SUBJECT: ST. LUCIE UNIT 1 - ISSUANCE OF AMENDMENT RE: REACTOR COOLANT SYSTEM PRESSURE/TEMPERATURE LIMITS (TAC NO. M92412)

AMENDMENT NO. 141 TO FACILITY OPERATING LICENSE NO. DPR-67 - ST. LUCIE, UNIT 1

ATTACHMENT TO LICENSE AMENDMENT NO. 141  
TO FACILITY OPERATING LICENSE NO. DPR-67  
DOCKET NO. 50-335

**FIGURE 3.1-15  
 MAXIMUM ALLOWABLE HEATUP AND COOLDOWN RATES,  
 SINGLE HPSI PUMP IN OPERATION  
 (23.6 EFPP)**

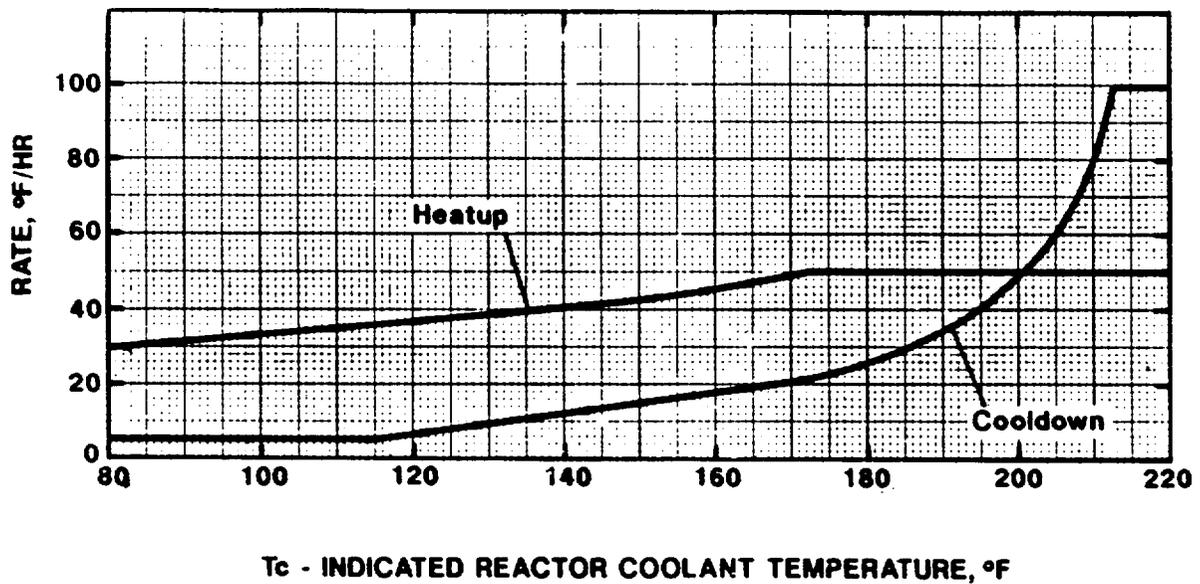
The limiting mass addition and energy addition transients have been analyzed. The mass addition transient is based on the maximum possible pumping capacity available. Technical Specifications 3.1.2.1 and 3.1.2.3 have a footnote that requires two of four isolation valves in the operable high pressure safety injection header be verified closed with power removed when a high head safety injection pump is being used for the boration flow path. This requirement assures the amount of water that can be pumped into the RCS is limited while one of these pumps is in operation. The current requirement is that these valves be verified closed with power removed whenever the high head safety injection pump is in service. The amendment requires that the valves be verified closed with power removed only when the high head safety injection pump is in service and when RCS pressure boundary exists. Removing the requirement to verify the two valves are closed with power removed is acceptable because only when RCS pressure boundary is established can a mass addition transient cause an over pressure event. If the RCS pressure boundary is not established, there is no chance of over pressurizing the RCS. The burden of verifying the valves are closed and power is removed is, therefore, not necessary when RCS pressure boundary is not established. The licensee proposed changes to Technical Specifications 3.1.2.1 and 3.1.2.3 are acceptable.

\* The flow path from the RWT to the RCS via a single HPSI pump shall only be established if: (a) the RCS pressure boundary does not exist, or (b) no charging pumps are operable. In the latter case: 1) all charging pumps shall be disabled; 2) heatup and cooldown rates shall be limited in accordance with Figure 3.1-1b; and 3) at RCS temperatures below 115°F, any two of the following valves in the operable HPSI header shall be verified closed and have their power removed:

**FIGURE 3.4-2a**  
**ST. LUCIE UNIT 1 P/T LIMITS, 23.6 EFY**  
**HEATUP AND CORE CRITICAL**

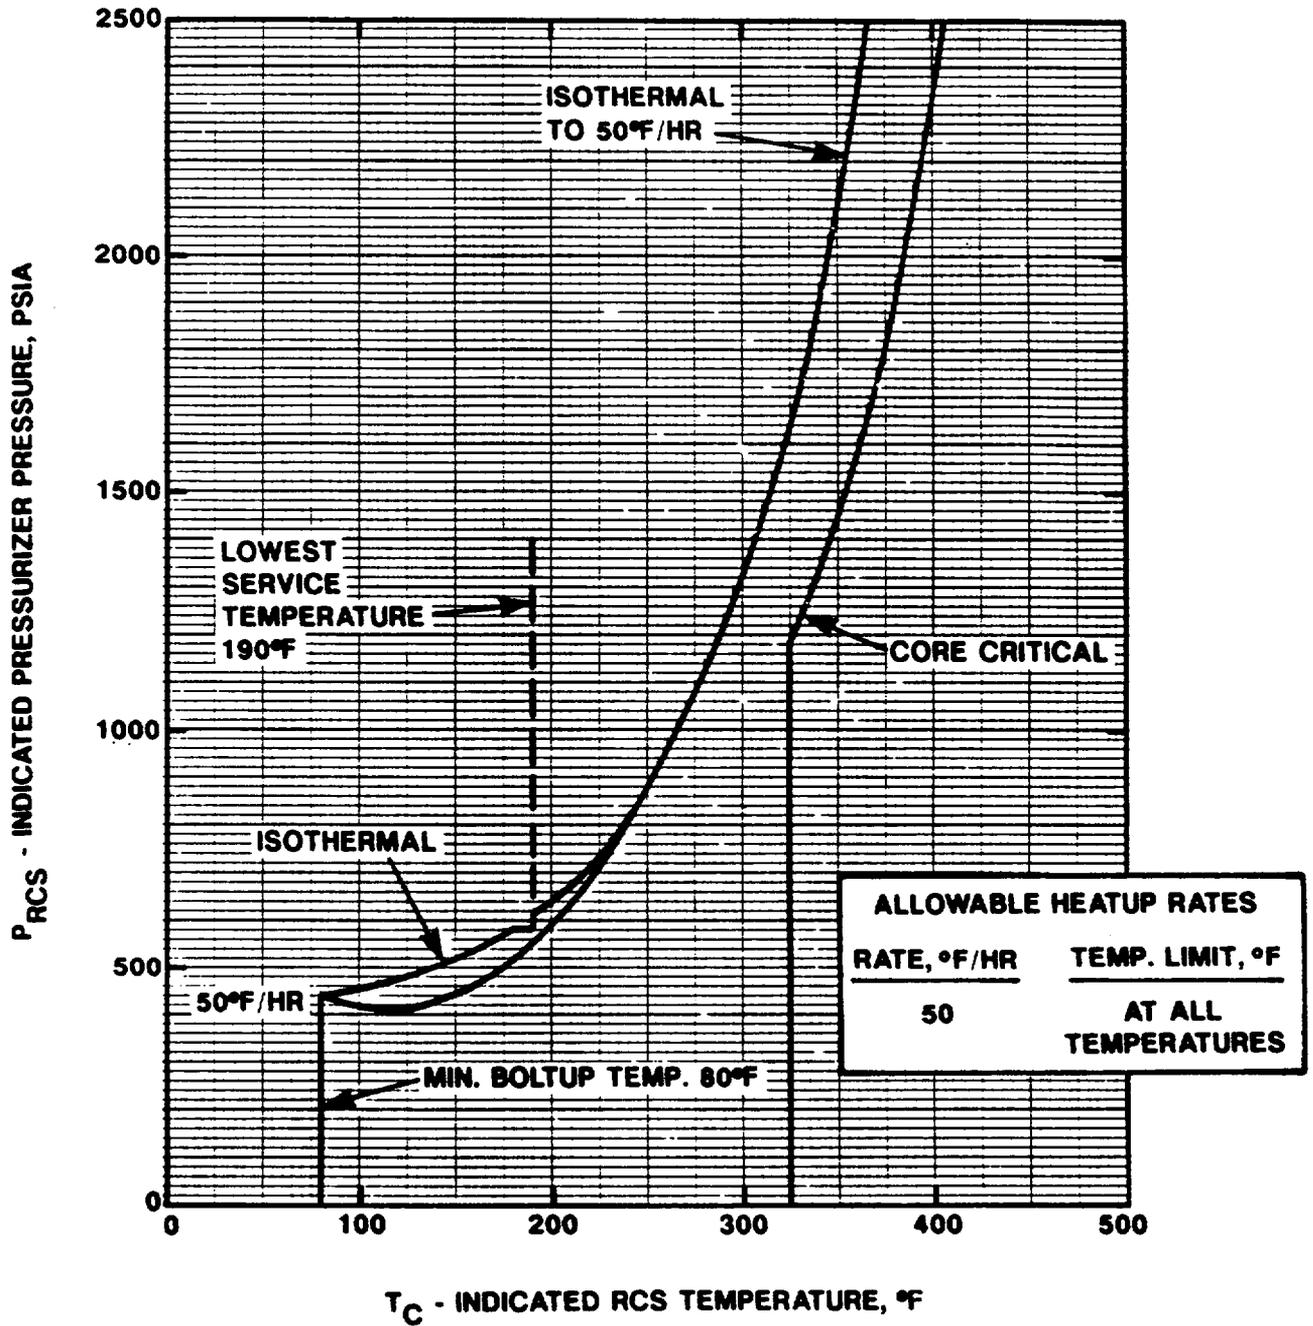
The staff judges that a difference of  $0.5^{\circ}\text{F}$  between the licensee's ART of  $191^{\circ}\text{F}$  and the staff's ART of  $191.5^{\circ}\text{F}$  is negligible. Further, since the licensee back-calculated the fluence in this application based on the ART of  $191^{\circ}\text{F}$ , which is the same as that appeared in the 1989 P/T limits submittal, the proposed P/T limits for heatup, cooldown, and hydrotest are identical to the current P/T limit curves and meet the beltline material requirements in Appendix G of 10 CFR Part 50. The only changes made in Figure 3.4-2a and Figure 3.4-2b by the licensee are EFPY values in the legends associated with these P/T limit curves.

The staff concludes that the proposed P/T limits for the reactor coolant system for heatup, cooldown, leak test, and criticality are valid through 23.6 EFPY because the proposed limits conform to the requirements of Appendices G and H of 10 CFR Part 50. The proposed P/T limits also satisfy GL 88-11 because the method in RG 1.99, Rev. 2 was used to calculate the ART. Hence, the proposed P/T limits may be incorporated into the St. Lucie 1 Technical Specifications.
